APPENDIX A
REVISED FIGURES

Revised Figure 2.4. Flowline/Umbilical Routing to Glory Hole

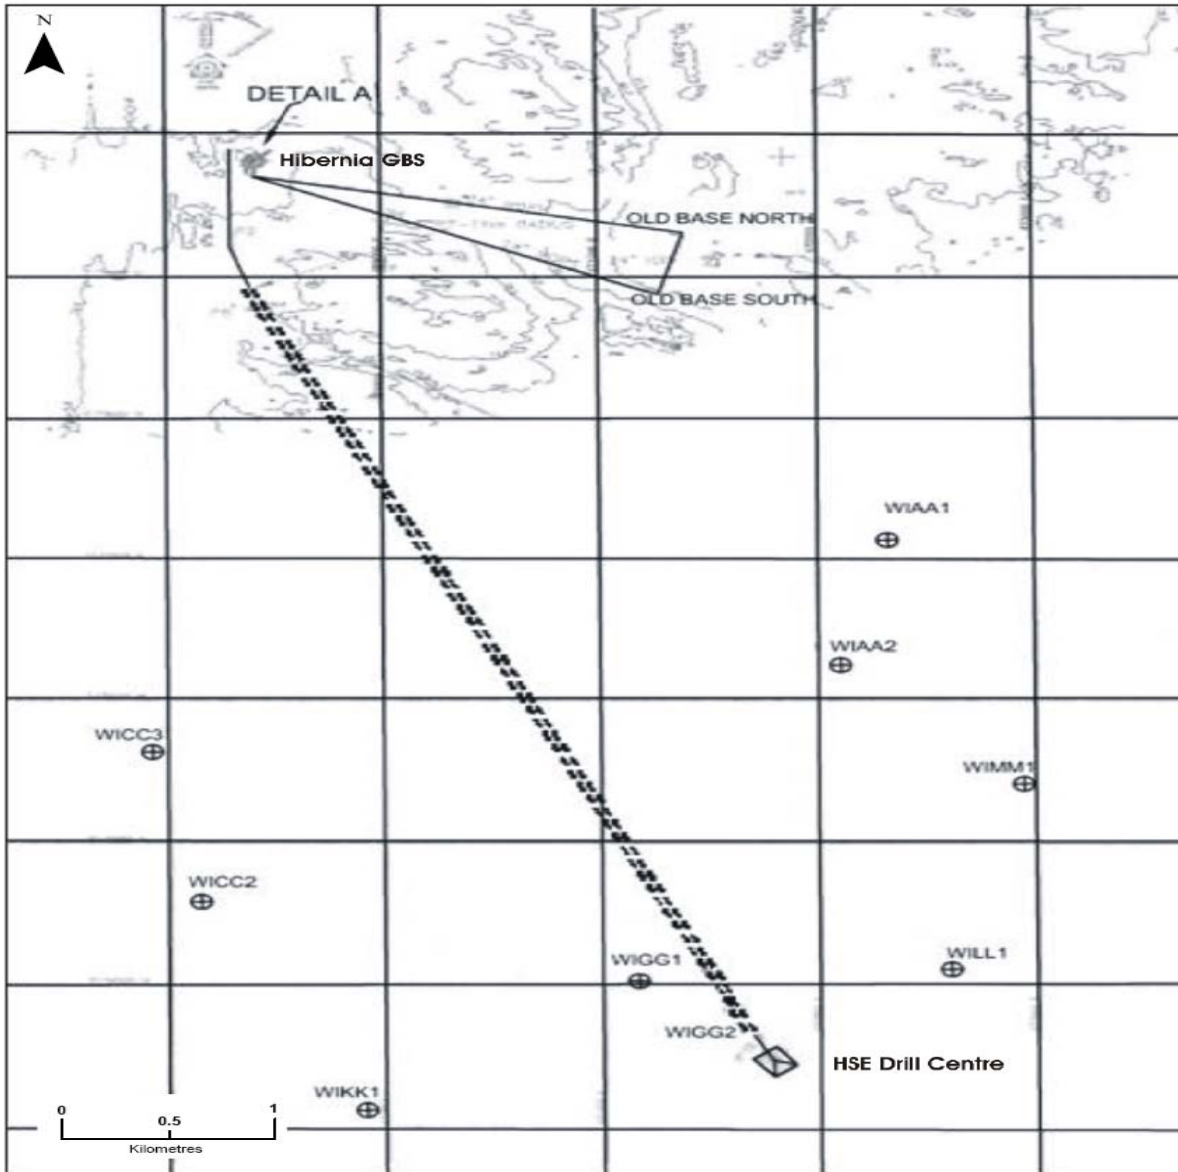
Regulatory Comment March 2, 2009	HMDC Response April 27, 2009	Regulatory Comment June 15, 2009	HMDC Response June 17, 2009	Regulatory Comments July 23, 2009	HMDC Response July 24, 2009	Regulatory Comment August 31, 2009	HMDC Response September 12, 2009
suction dredge to handle? If so, there should be a contingency plan and possible inclusion in the disposal at sea permit.	boulders out of the glory hole by "dragging" the boulders with the drag head up the side of the glory hole. It is not common but can be done if necessary. There would be no intention of taking such boulders to the disposal site.						
S8. §2.1.3 Geohazard and Vertical Seismic Profile Surveys, pg. 11 – The last paragraph of this section does not belong in the project description.	Paragraph removed.						
S9. Figure 2.4, pg. 15 – The scale and direction should be included in figure.	Approximate scale and direction have been included in Figure 2.4. Revised figure is attached in Appendix A,
